APPENDIX N. PUBLIC COMMENT LETTERS AND RESPONSES

Appendix N-1: 2024 Plan Public Comment Letters and Responses

RE: Kern County Subbasin May 2024 Draft Groundwater Sustainability Plan - Subsidence

RE: Response to Western State Petroleum Association (WSPA) Comments Dated August 29, 2024, on the May 2024 Draft Groundwater Sustainability Plan (GSP), Kern County Subbasin, Related to Land Subsidence.

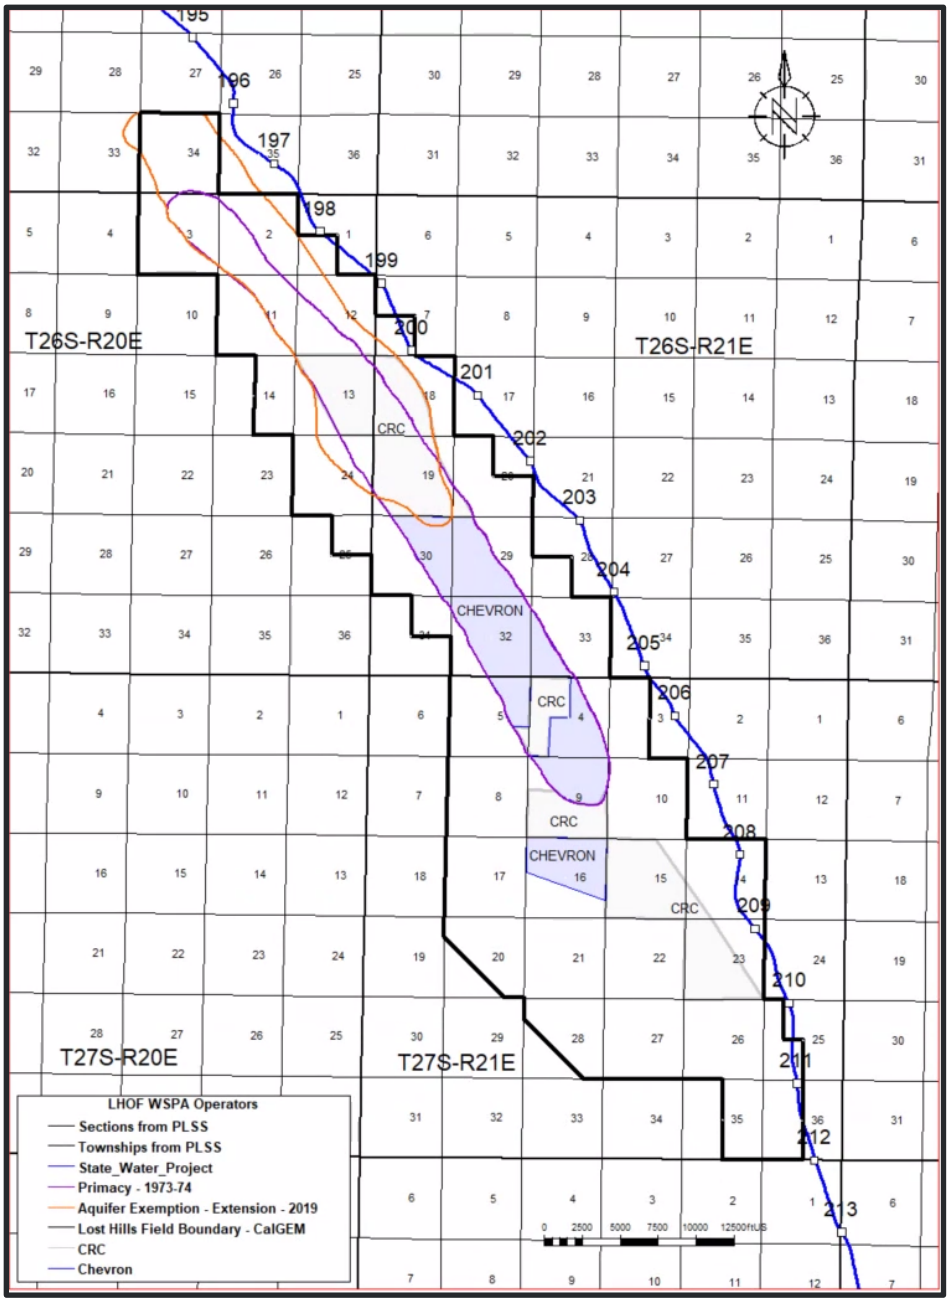
- GSAs' Response to WSPA Comment #7: The GSP's focus on the LHOF administrative boundary as a means to argue that LHOF subsidence reaches the Aqueduct is misplaced. Where the actual operations occur within the LHOF—not the administrative boundary—is what matters when considering subsidence. As illustrated in the figure below, WSPA LHOF operations occur roughly 1.0 mile from the Aqueduct.

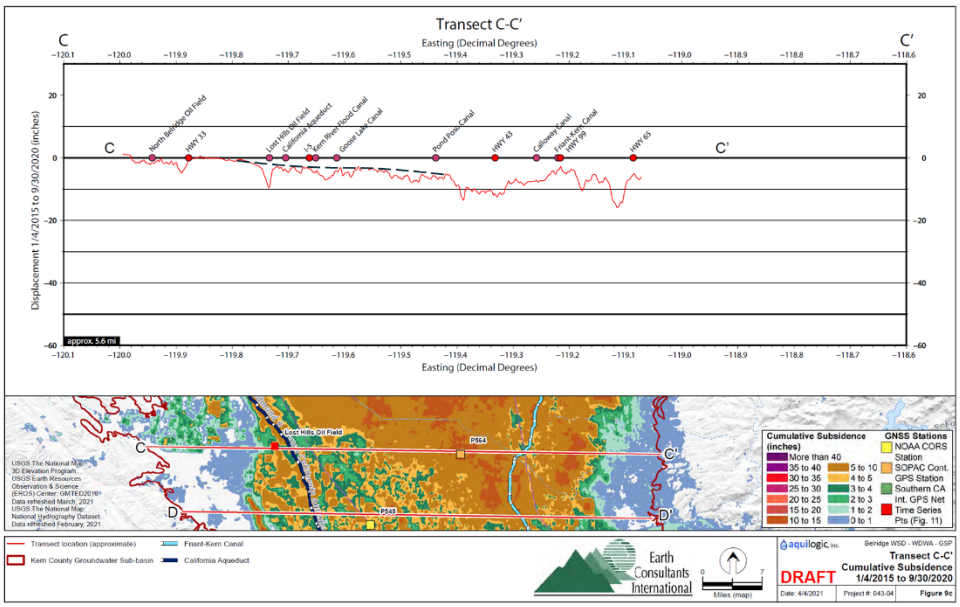
- GSAs' Response to WSPA Comment #9: WSPA LHOF operators recognize that their operations cause localized subsidence within the LHOF. However, analysis of available data confirms that this localized LHOF subsidence does not extend laterally to the Aqueduct. Moreover, the ECI 2021 Report figure 9c reproduced below identifies a regional subsidence trend throughout the Kern County Subbasin that is caused by activity other than LHOF operations. The June 2025 GSP fails to consider or discuss this regional subsidence trend or how the trend impacts the GSP's apparent conclusion that LHOF activities are responsible for the observed subsidence in the vicinity of the Aqueduct.

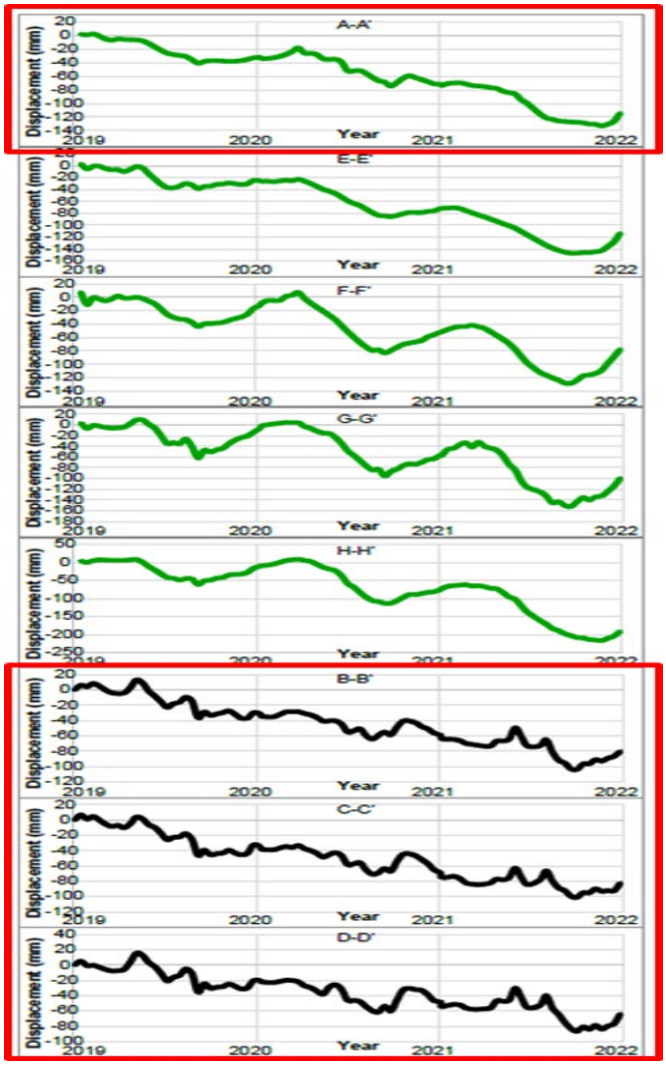
- GSAs' Response to WSPA Comment #12: WSPA disputes the GSAs' conclusion that seasonality observed in curves plotting InSAR land subsidence demonstrate a difference between GSA and non-GSA causes of land subsidence. As an initial matter, three years of subsidence measurement is inadequate to illustrate subsidence characteristics, as illustrated in GSP figure No. 8-83 reproduced below (showing subsidence curves for the three-year period 2019 to 2021). In any event, there is little difference in the land subsidence transect for A-A' (allegedly showing subsidence associated with agricultural activity) and transects B-B', C-C' and D-D' (allegedly showing subsidence associated with LHOF oil and gas operations). Land subsidence shows sinusoidal signature in areas where groundwater extraction is the primary source of water for agriculture and crop demand, which is seasonal. Subsidence due to other "GSA factors" does not

necessarily show strong seasonal signatures, depending on crop types and rotation patterns, surface water availability, and other non-agriculture water use.

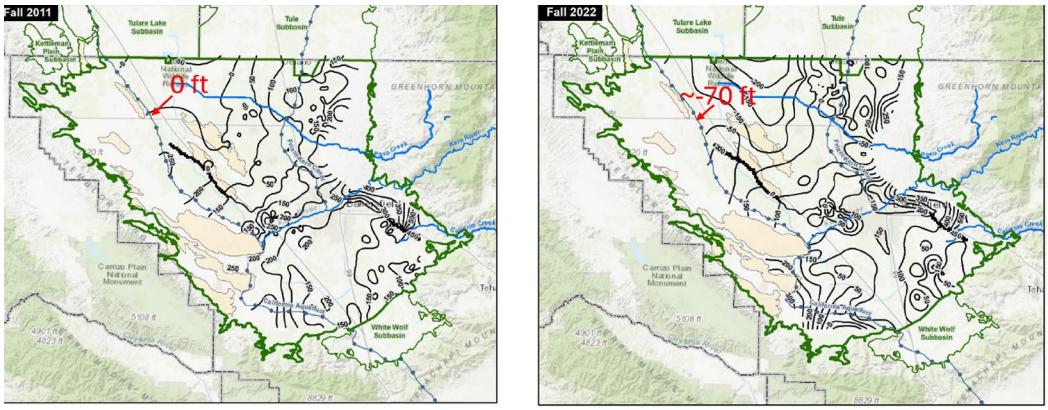
- Failure to Consider Groundwater Decline Impacts on Subsidence: As figure 8-4 of the June 2025 GSP reproduced below recognizes, regional groundwater in the vicinity of the Aqueduct has declined about 70 feet between 2011 and 2022. The cause of regional groundwater decline is not attributed to operations at the LHOF. However, the GSP provides no discussion of the impact of regional groundwater decline on Aqueduct subsidence.

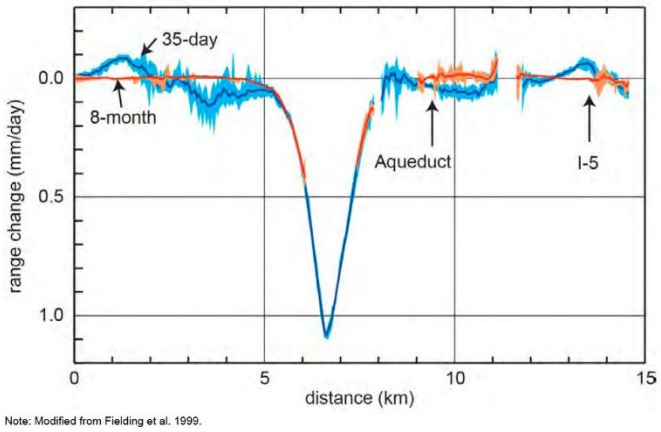
also shows an additional source(s) of subsidence between the LHOF and the Aqueduct as illustrated in figure 3-3 of CASP 2019 Report as illustrated below.

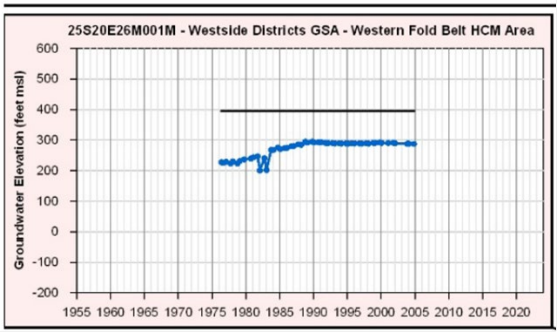
- Groundwater Monitoring on the West Side of the Subbasin: As illustrated in figure 15-6, no groundwater monitoring is proposed on the West Side, including proximate to the LHOF. This is problematic because without monitoring it will not be possible to differentiate between GSA and non-GSA attributable subsidence. Additionally, figure 8-7, reproduced below, includes a graph of monitoring well 25S20E26M0010[7] as evidence of stable groundwater elevations in the Western Fold Belt HCM. This single representative hydrograph does not demonstrate current (or future) stable groundwater elevations because it is limited to the timeframe of 1975 to approximately 2004—i.e., the data provided ends more than 10 years before SGMA was enacted. It is inappropriate to draw the conclusion that groundwater elevation is stable without considering what is happening during the relevant SGMA timeframe commencing in 2015.

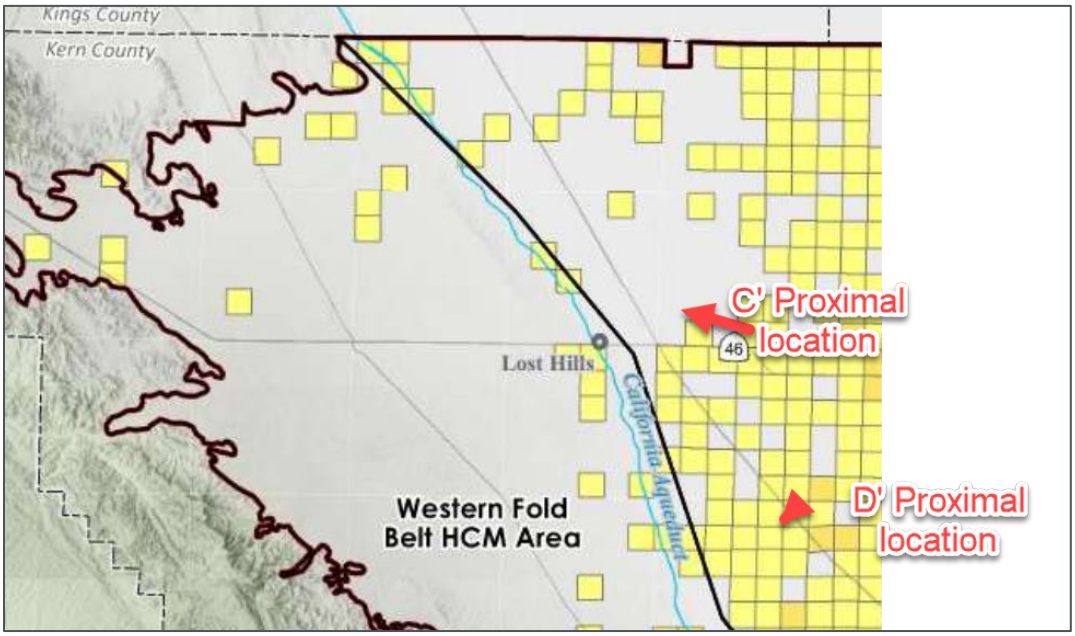
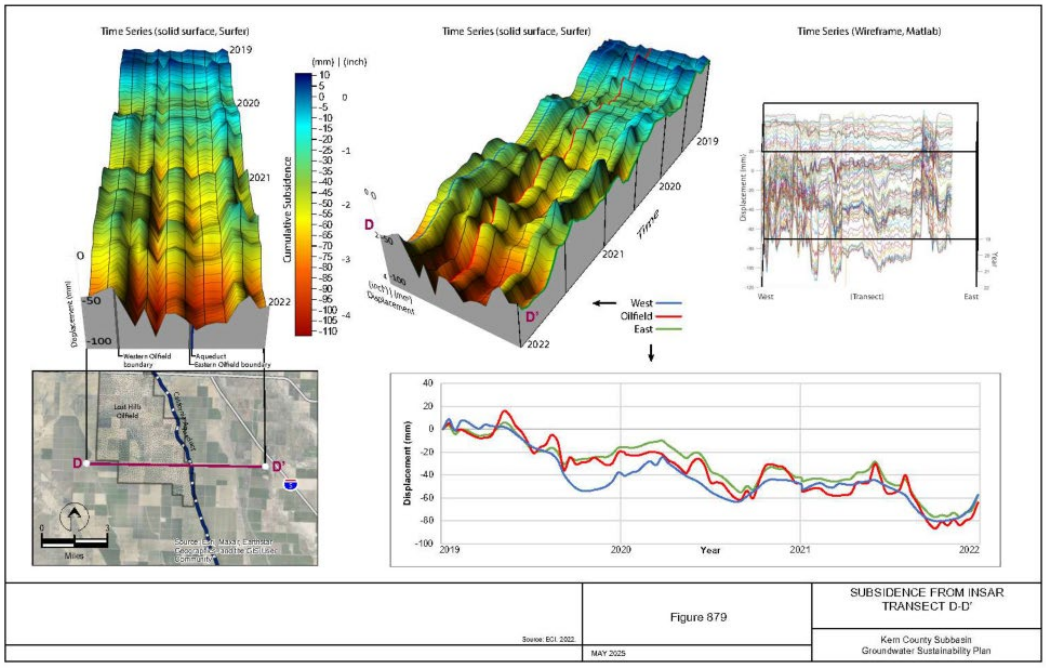
- Failure to Analyze Subsidence East of the Aqueduct with Actual Groundwater Pumping Volumes Within the GSA's Authority: The June 2025 GSP for the Lost Hill area does not identify any volumes associated with groundwater pumping wells in the Western Fold HCM Area. However, the June 2025 GSP figure 5-12 shows the presence of groundwater wells east of the Aqueduct in a number of cells as illustrated by the figure below.

Specifically, figure 5-12 highlights sections of grid having between 1 and 5 production groundwater wells. If you compare figure 5-12 to figures 8-77 and 8-78 reproduced below, it is visible that the eastern half of the cross section goes into areas where there is groundwater pumping. For reference, C' data point is on the east side of the I-5 and D' is just west of the I-5. Figure 5-12 shows a number of grid cells that contain groundwater wells west of the I-5 yet the June 2025 GSP provides no data on groundwater pumping in that area. The eastern edge of the subsidence impacts are far east of LHOF and overlap with the grids showing groundwater wells in figure 5-12. This GSA-related data is omitted from the June 2025 GSP. Rather than omitting it, the data should be considered in the June 2025 GSP. Further, the cross sections in figures 8-77 and 8-78 show improvement in subsidence west of the Aqueduct and then a second bowl east of the Aqueduct. The subsidence impacts east of the Aqueduct need to be studied in relation to the groundwater wells represented by the yellow cells in figure 5-12.

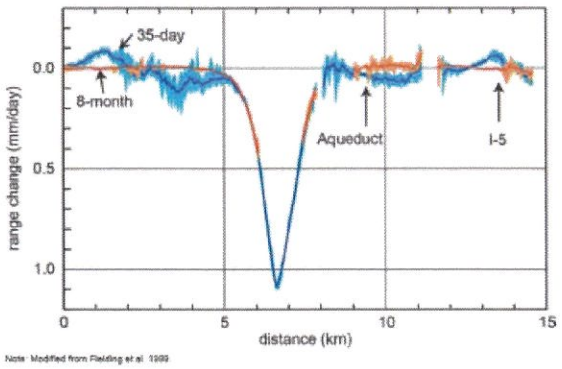
- As illustrated in the image below, the findings of the DWR 2019 Report, as well as the 2023 Earth Consultant International report and Chevron's own independent analysis confirm localized subsidence from Chevron's LHOF operations fully attenuates prior to reaching the Aqueduct and that another source or sources cause an eastward increasing subsidence observed between Chevron's LHOF operations and the Aqueduct.

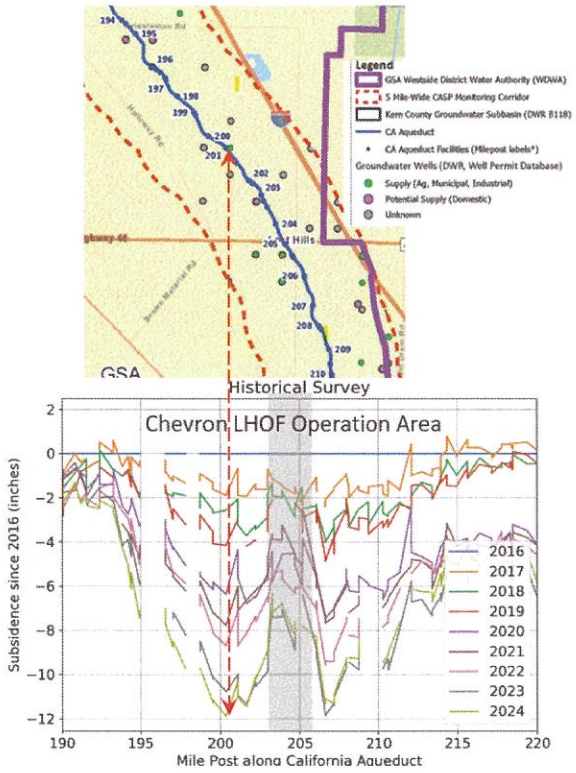
- The GSP's claim that there is limited to no groundwater being pumped for GSA-related purposes in the northwestern part of the Kern County Subbasin is inconsistent with available data. As noted in Section 5.6.1 of the June 2025 GSP, the GSAs have yet to complete the Subbasin-wide well inventory making any claims related to groundwater pumping in the northwestern part of the Subbasin premature. Moreover, groundwater monitoring well 21MW-5, screened between 565.8 - 595.0 ft below ground surface (below the Corcoran clay) just to the east of the Aqueduct MP 202 to monitor the cleanup activities associated with a former percolation pond, shows groundwater depths declined by roughly 2.8 ft/yr between 2015 and 2023. This data shows that groundwater extraction, unassociated with the LHOF is occurring. Similarly, the June 2025 GSP Appendix N figure at page 56, which identifies groundwater supply wells in the vicinity of the Aqueduct, includes a supply well at approximately MP 200, immediately adjacent to the Aqueduct as illustrated below. The June 2025 GSP does not provide any information on the draw down from this well or its general usage. Likewise, the figures show that surveyed Aqueduct subsidence is less between MP 203-206, which correlates with less agricultural activities in the vicinity of the Aqueduct east of the primary area of Chevron's LHOF operations.

Contrary to the GSAs' claims, these examples show that there is a GSA-related subsidence factor (i.e., groundwater pumping) in the vicinity of the Aqueduct that needs to be evaluated
